MORGANTOWN BOARD OF ZONING APPEALS

STAFF REPORT

CASE NO: COMBINED REPORT – CU12-20 / V12-38 / CU12-21
Metro Towers, LLC / University Avenue

Request by Lisa Mardis of Project Management Services, on behalf of Metro Towers, LLC, for the following approvals relating to a proposed apartment building on University Avenue.

2
DRAWING NO.

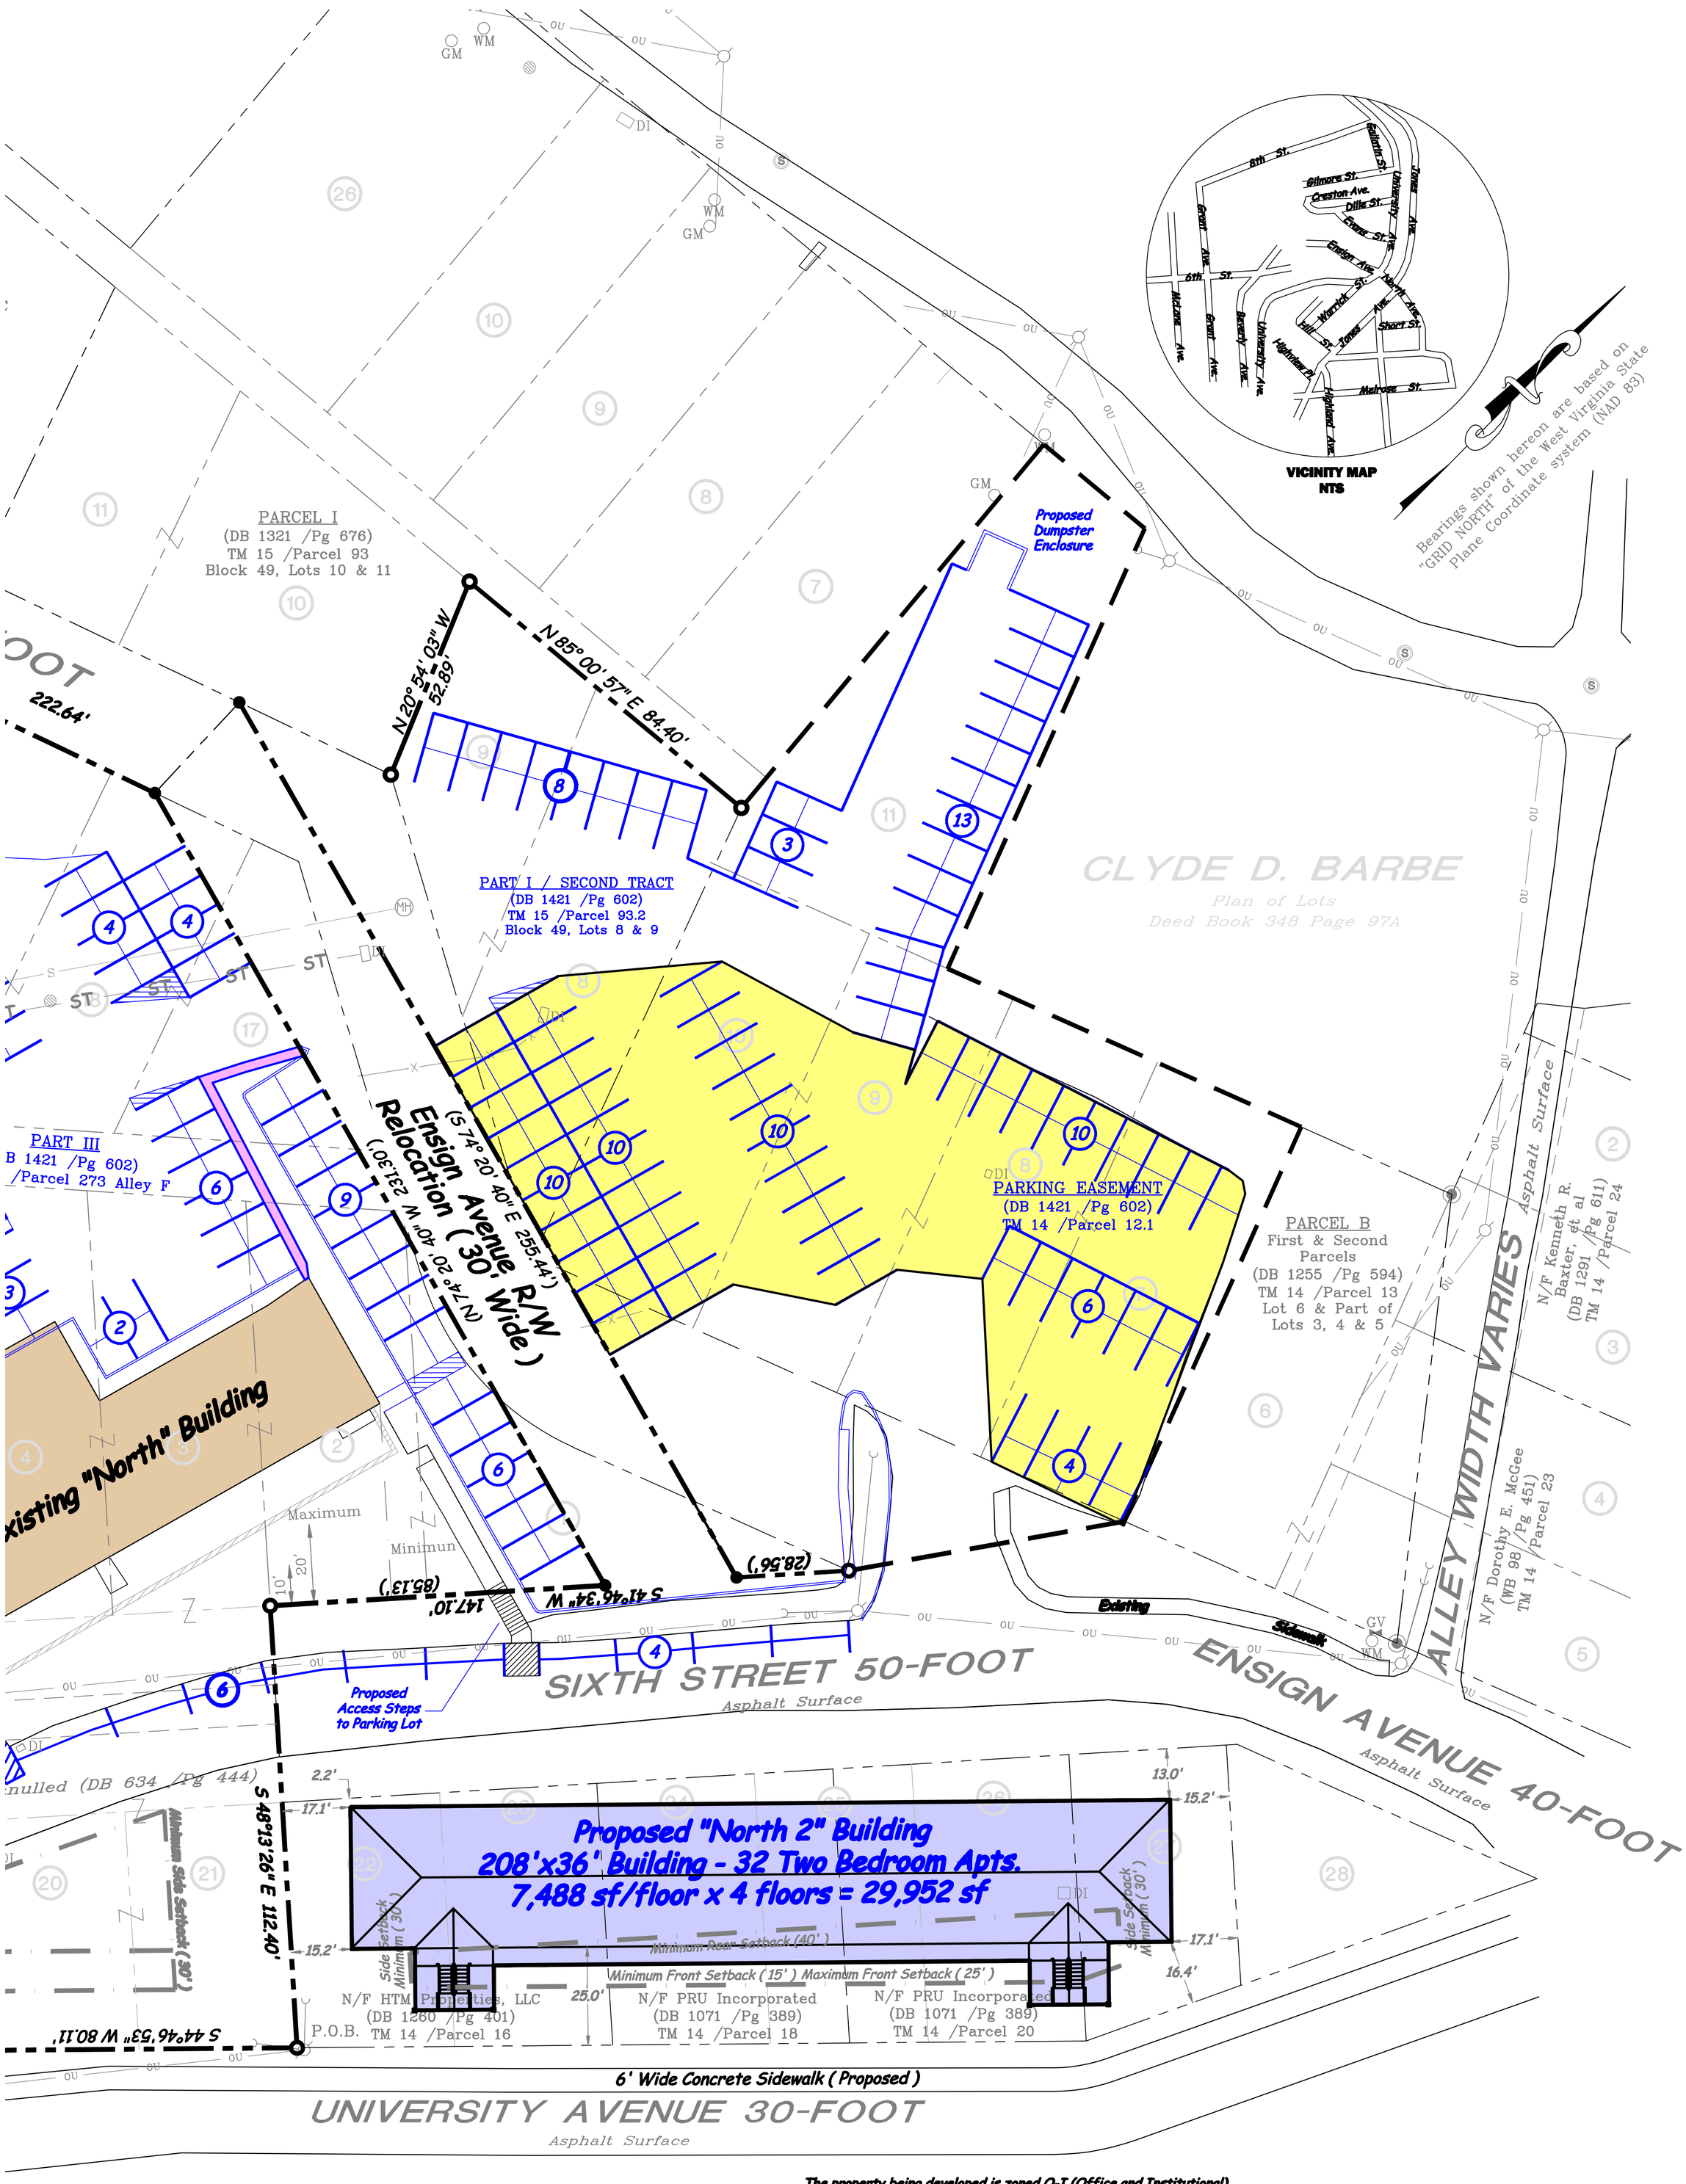
The minimum parking requirement for the proposed "North 2 Building" is 50 spaces; 48 spaces for the residential use and 2 spaces for the employees of the property management office use. Because the "North 2 Building" development site is separated from the main Metro Towers "campus" by the Sixth Street right-of-way, **conditional use** approval is required to dedicate at least 50 off-site parking spaces on the main "campus" parcels.

1. That an accessible route to the off-site parking area meet all applicable federal Fair Housing and Americans with Disabilities Act standards as determined by the City's Chief Building Code Official.

2. That the off-site parking facility be encumbered by an easement or similar agreement, to the satisfaction of the Planning Division, which is duly executed and acknowledged and specifies that the land upon which the subject off-site parking facility is located is encumbered by the parking use of the subject development for no less than fifty (50) parking spaces. That this instrument must bind the use for the life of the multi-family dwelling use. That said instrument must be filed with the Planning Division and placed on public record in the Office of the Clerk of the County Commission of Monongalia County, West Virginia. That the Certificate of Occupancy for the subject dwelling space shall be contingent upon the continuance of said agreement and encumbrance and should said agreement and encumbrance be annulled for any reason at any time, said Certificate of Occupancy shall be revoked upon written notification by the Planning Division. That a valid and current copy of said instrument must be made available at the request of Planning Division.

3. That the proposed fifty (50) spaces shall have signs noting the rental unit for which the spaces are reserved. That such signage shall be 12 inches wide by 18 inches tall and shall be mounted between three feet and five feet above the finished surface of the parking stalls. That the text on the sign state "This space is reserved for residents located at [address assigned by City Engineer] only, per City Code 1365.07(D)."
